Illinois Environmental Protection Agency
Bureau of Land

Tiered Approach to Corrective Action Objectives (TACO) Fact Sheet 1: Introduction

RE: Response to U.S. EPA Comments
MW03S Area Investigation / ILD005078126
Millennium Petrochemicals, Inc. / Tuscola, Illinois

I've looked through the March 28, 2003 Assessment of Additional Areas of Concern for the AOCs at the Tuscola Plant. Overall it looks pretty good. I do have some comments I'd like you to address. They are listed below:

PROPOSED SAMPLE LOCATIONS
 FORMER ETHYLENE PRODUCTION AREA

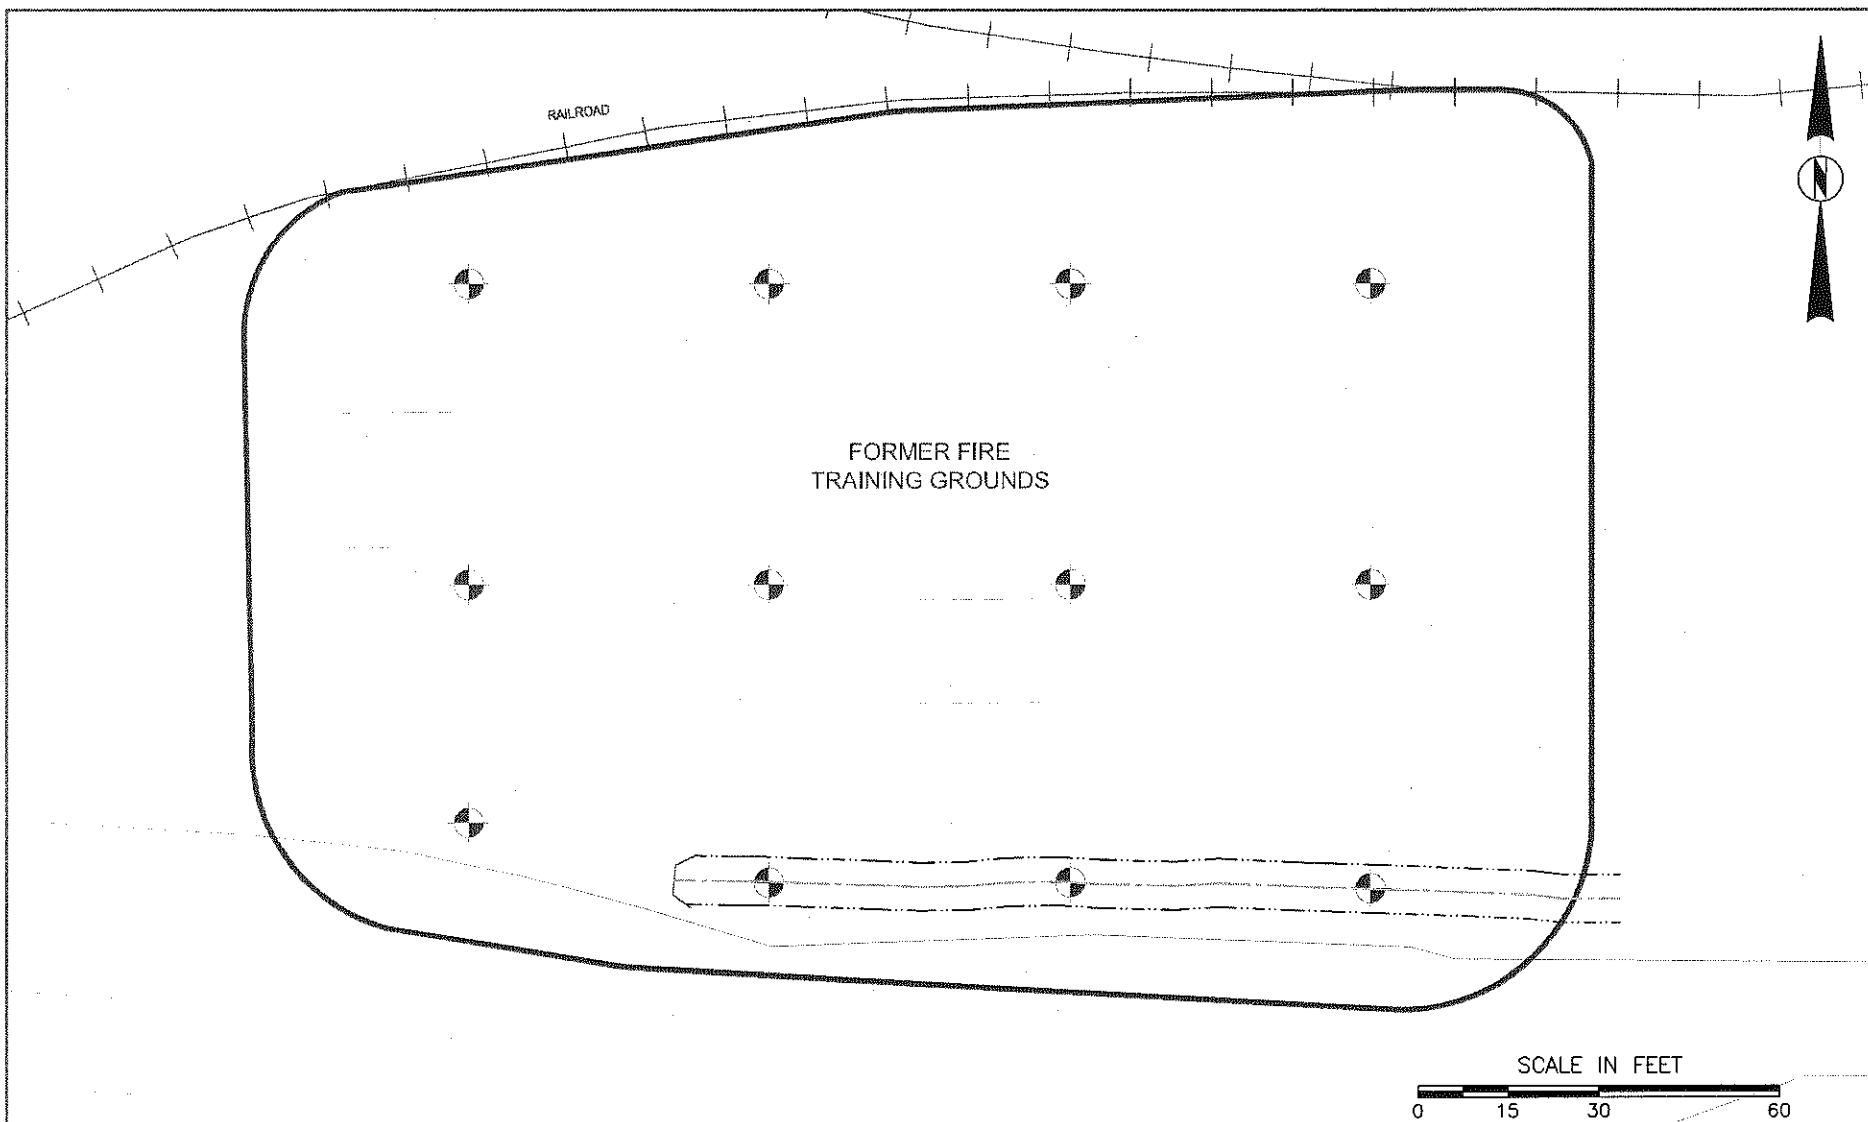
Comment 2:

sumps may have been present in the Former Ethylene Production Area. They appear to have been clustered in the central portion of the area (within 3 distinct areas of the central portion). All appear to have drained to manholes where sampling is already proposed. Never the less, we propose adding three new borings (one in each of the distinct areas identified as having sumps), assuming these areas (or sumps) can be located. A revised Figure 4 is attached showing the three additional boring locations. OK

Response: A review of available facility drawings indicates that 30
